LR-N96114
LCR S94-41

**REQUEST FOR CHANGE TO TECHNICAL SPECIFICATIONS
MARGIN RECOVERY PROGRAM
SALEM GENERATING STATION NOS. 1 AND 2
FACILITY OPERATING LICENSES DPR-70 AND DPR-75
DOCKET NOS. 50-272 AND 50-311**

SALEM GENERATING STATION UNIT NOS. 1 AND 2
FACILITY OPERATING LICENSES DPR-70 AND DPR-75
DOCKET NOS. 50-272 AND 50-311
CHANGE TO TECHNICAL SPECIFICATIONS
MARGIN RECOVERY PROGRAM

Illustration of Overtemperature and Overpower
 ΔT Protection

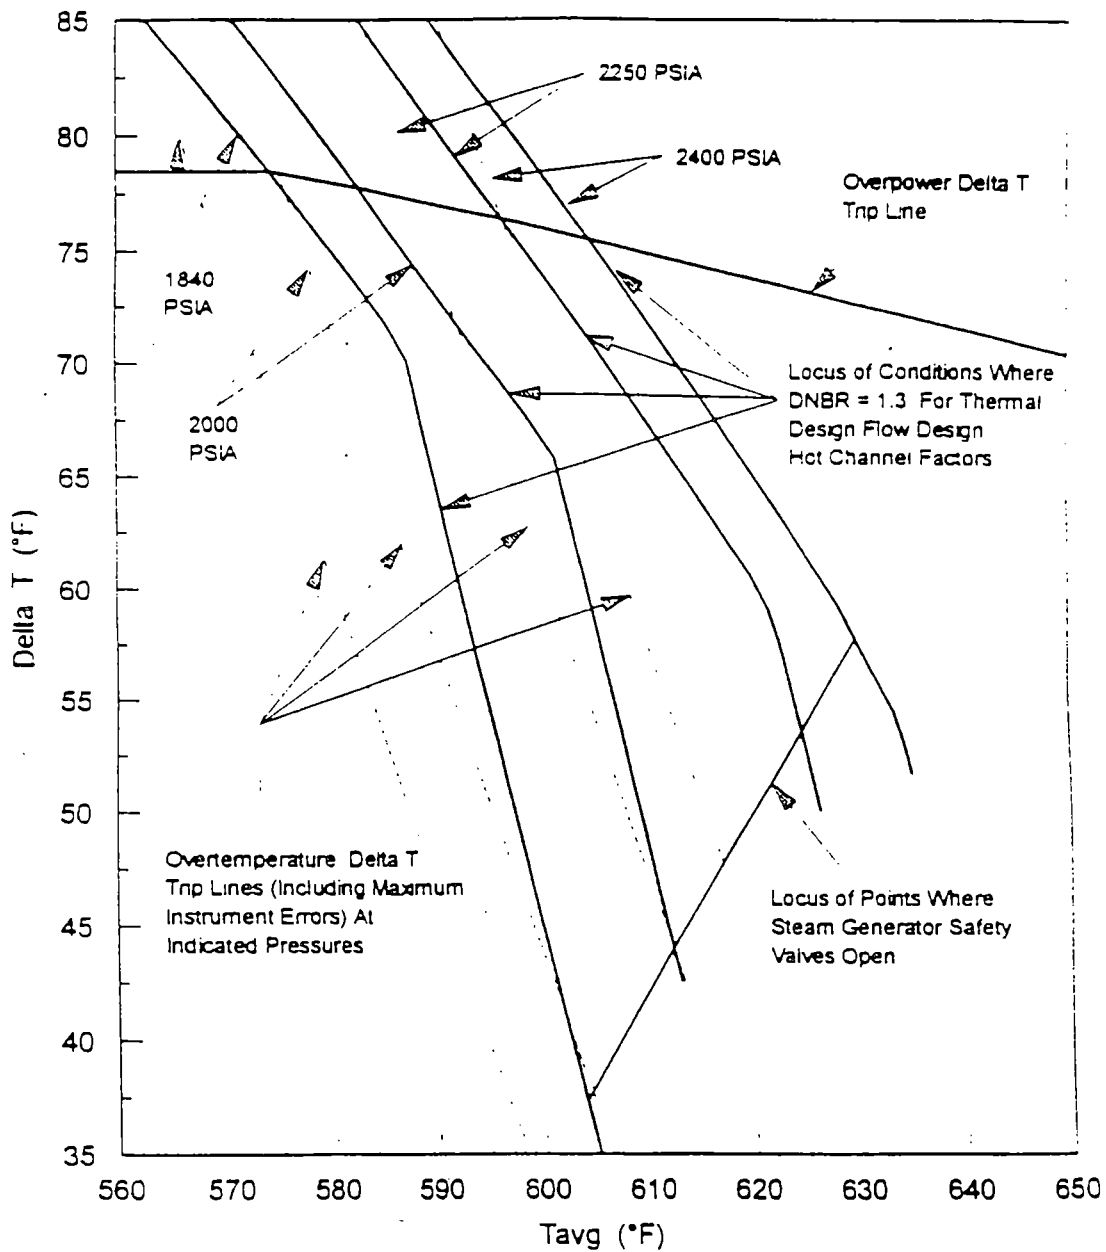
The overtemperature - and overpower-DT (OT/OPDT) setpoints were recalculated for the FU/MRP based on the most conservative core limits. The most conservative core limits were based on RTDP safety limits as described in RTSR Section 4.0. The core limits used to calculate the OT/OPDT setpoints are provided in Figure 4.1-1 and in Tech Spec Figure 2.1-1. The UFSAR events that rely on OT/OPDT for protection were reanalyzed to reflect the setpoint changes, as provided in the revised Tech Specs. It has been confirmed that these OT/OPDT setpoints protect the core safety limits as shown in Figure 4.1-2.

FIGURE 2.1-1 REACTOR CORE SAFETY LIMIT - FOUR LOOPS IN OPERATION

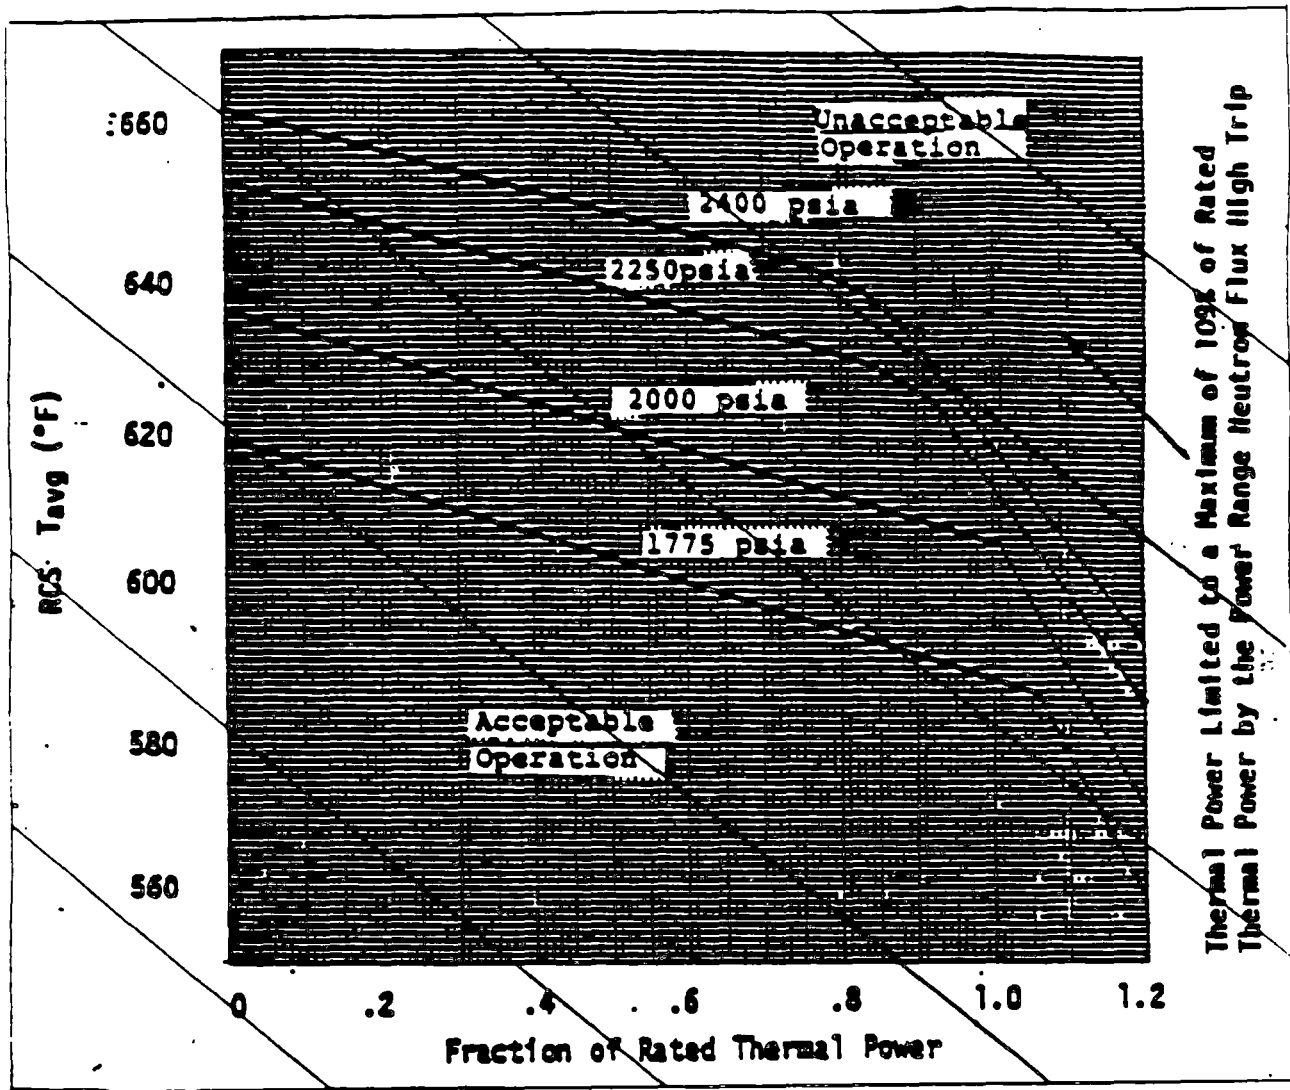
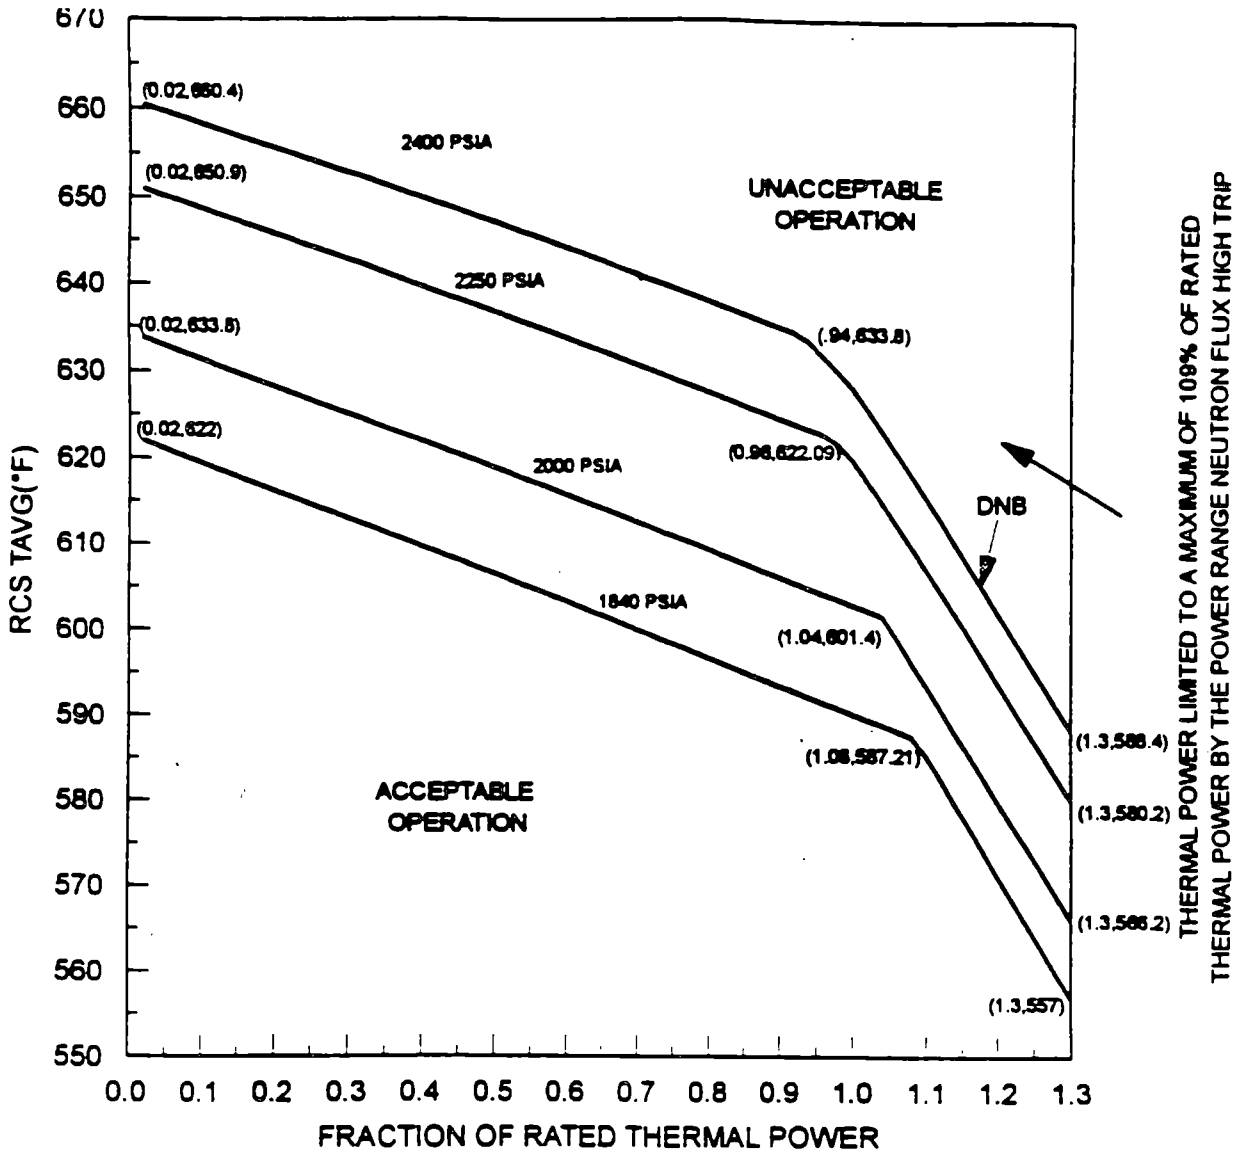
Reactor Core Safety Limits and Overtemperature Delta T (OT Δ T)/ Overpower Delta T(OP Δ T) Trip Functions - The equations for calculating the OT Δ T and OP Δ T trip setpoints are being revised. Figure 2.2-1 is being revised to reflect new core safety limits defining acceptable operation.

**Figure B 3/4 2-1 TYPICAL INDICATED AXIAL FLUX DIFFERENCE
VERSUS THERMAL POWER**

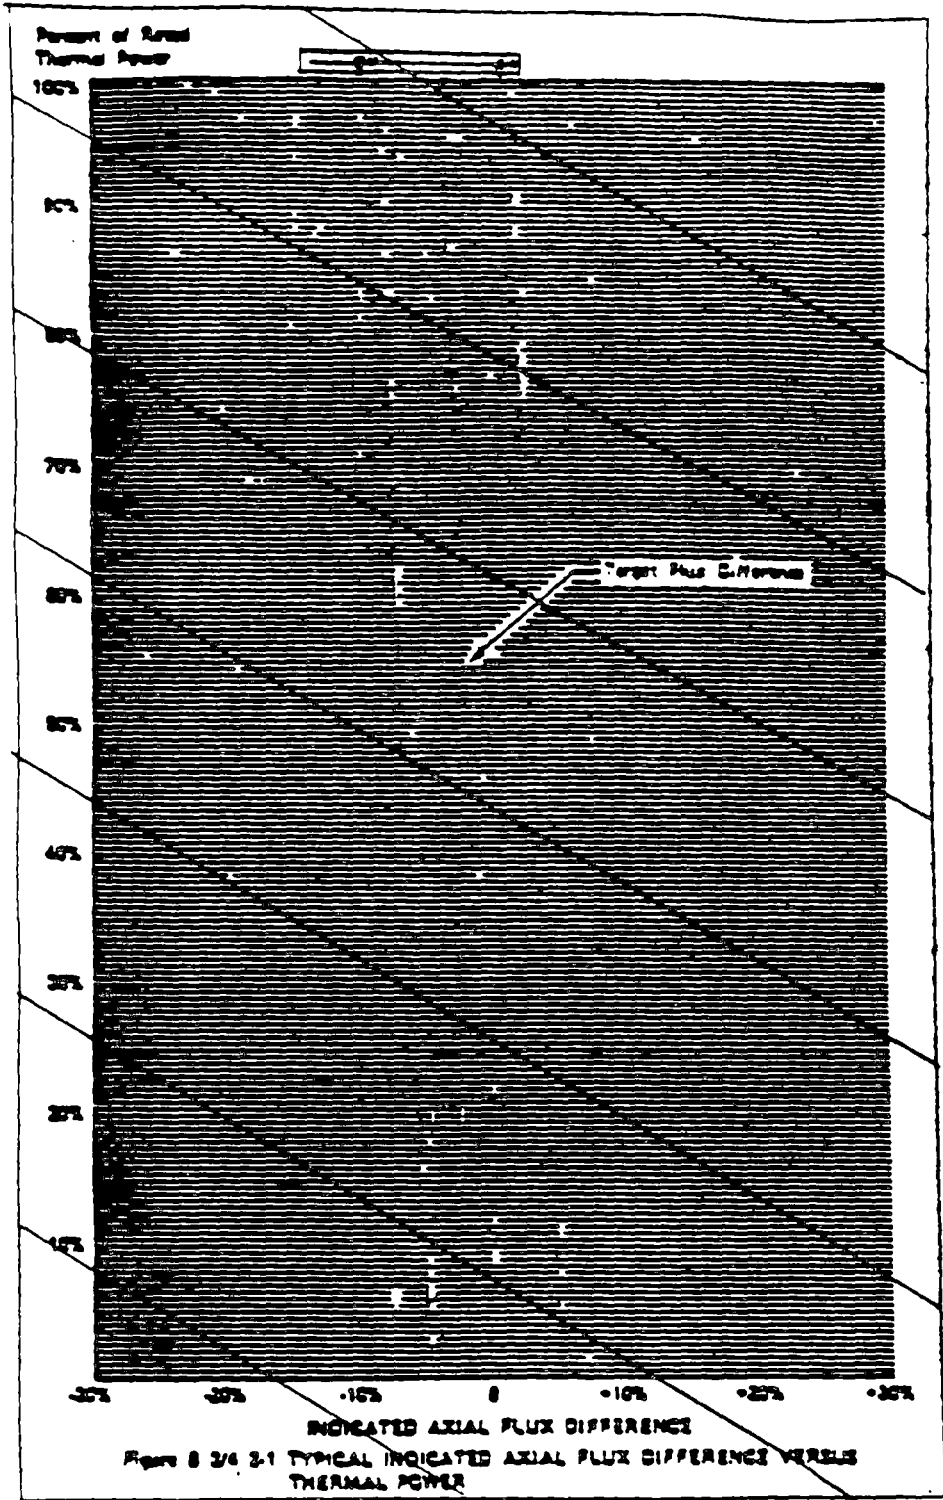
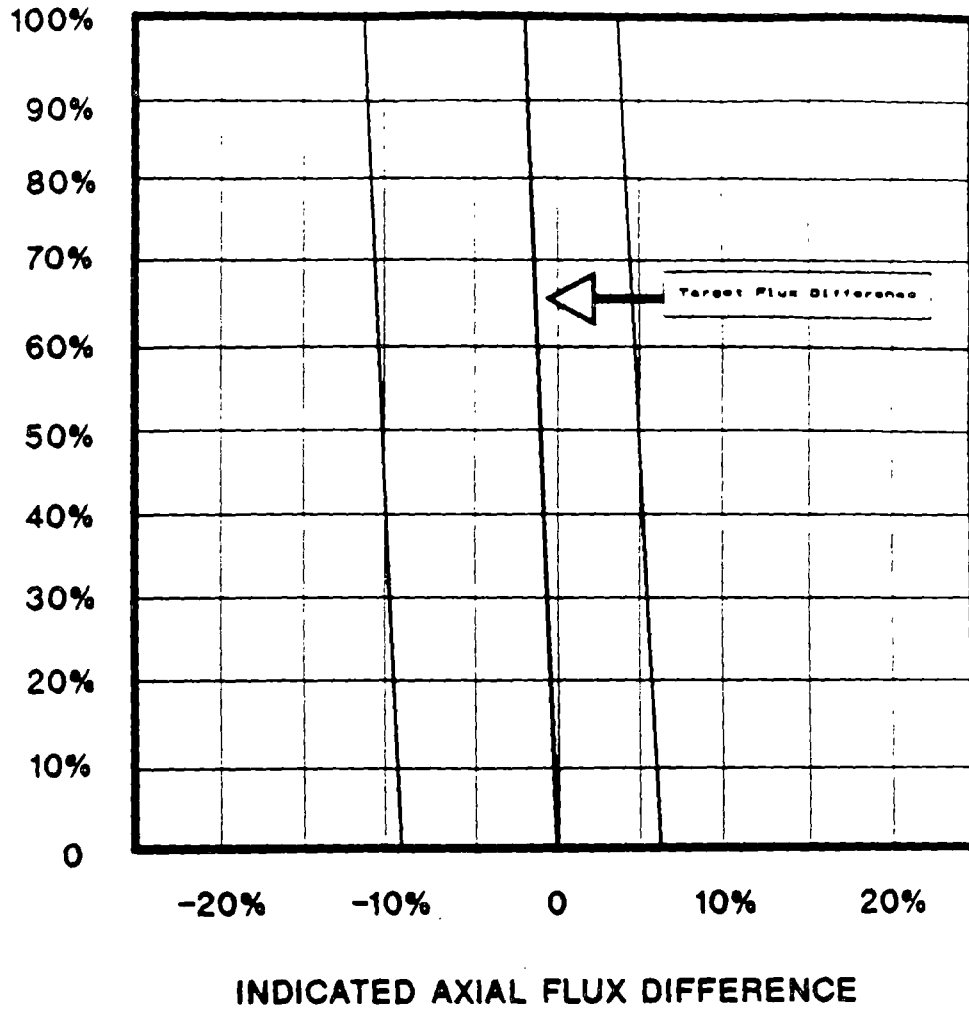
* REFER TO COLR FIGURE 2 FOR
ACTUAL LIMITS

**Figure B 3/4 2-1 TYPICAL INDICATED AXIAL FLUX DIFFERENCE
VERSUS THERMAL POWER**

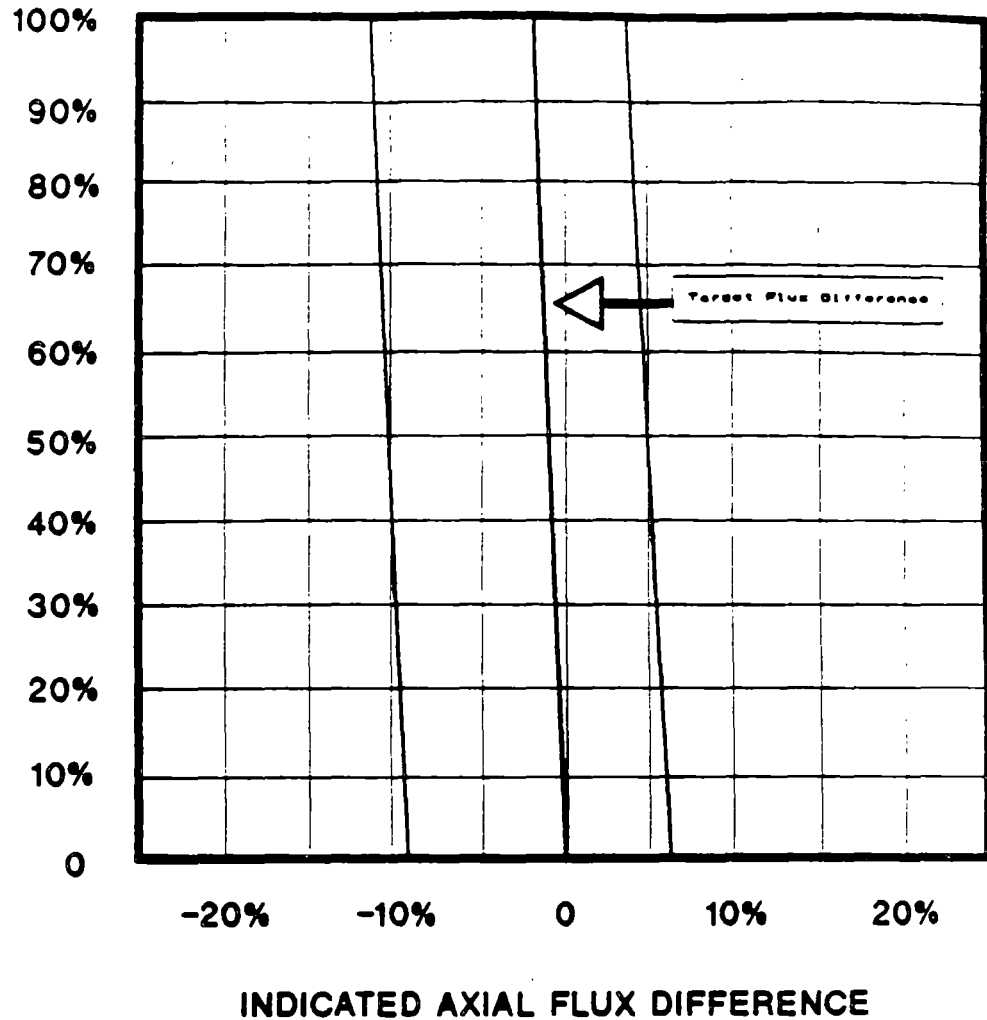
* REFER TO COLR FIGURE 2 FOR
ACTUAL LIMITS
